Office Action Summary

10/501,938

SEVERINI, JOSEPH

Claims 1-14 are rejected under 35 U.S.C. 103(a) as being unpatentable over US Patent No. 5,524,504 to Brandoli et al. in view of US Patent No. 5,286,076 to DeVoss et al.

FIG. 2

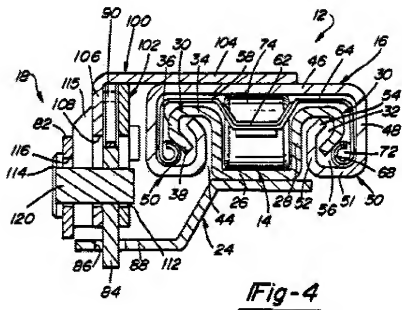
Brandoli et al. discloses all of the limitations of the claimed invention except for the flattened bearing surface. DeVoss et al. teaches the inner track having a bearing surface, which is flattened bearing surface (30, 34 Fig. 4) extending longitudinally along the inner track for smooth sliding movement between outer track and inner via planar surfaces 64 of the bearing retainer body assembly 58 (see attached Figure 4).

As to claim 2, wherein said inner track includes two upright sides (see attached figure) and a cross member extending laterally there between to define a U-shaped channel, said sides each having a distal end opposite said cross member.

As to claim 5, wherein said inner track includes an outer wall extending substantially perpendicularly from each of said outer edges to define a flange (see attached figure).

As to claim 7, wherein said outer track includes two upright sides and a base (see attached) extending laterally between said sides to define a U-shaped cross section, said sides of said outer track each including a distal end.

As to claim 8, wherein said base of said outer track includes a concavity (see attached figure) formed therein, said concavity protruding toward said inner track to define said arcuate bearing surface opposing said flattened bearing surface.
